**Now convert to new BPW shock absorbers.**  
Improved driving comfort, a smoother ride for the payload  
and weight saving.

## New BPW shock absorbers

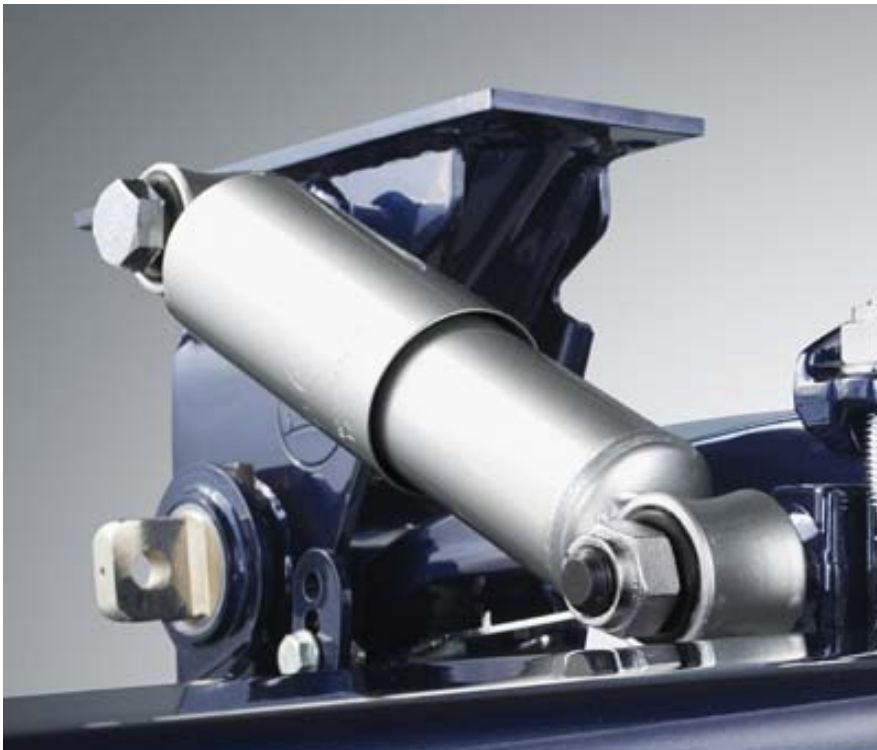
The further technical development of tried-and-tested BPW shock absorbers has delivered additional benefits:

- Very good damping properties because of optimised characteristics and improved response
- Optimised installation space because of a protective tube with a reduced diameter from 82mm to 75mm (lower tube 72 mm to 65 mm)
- Weight reduction by about 1 kg (per axle)
- Identical installation and connection dimensions compared to previous version guarantee 100% exchangeability

- Note that the units on each axle must be replaced as a set (2 identical dampers per axle)
- However, it is permitted to have different units on individual axles within the vehicle.
- The familiar "old" variants will be phased out and all will be replaced by the new variants
- This means there will be fewer variants, easier warehouse logistics and identification

BPW "old"	BPW "new"
02.3722.14.00	02.3722.83.00
02.3722.52.00	02.3722.83.00
02.3702.92.00	02.3722.88.00
02.3702.70.00	02.3722.89.00
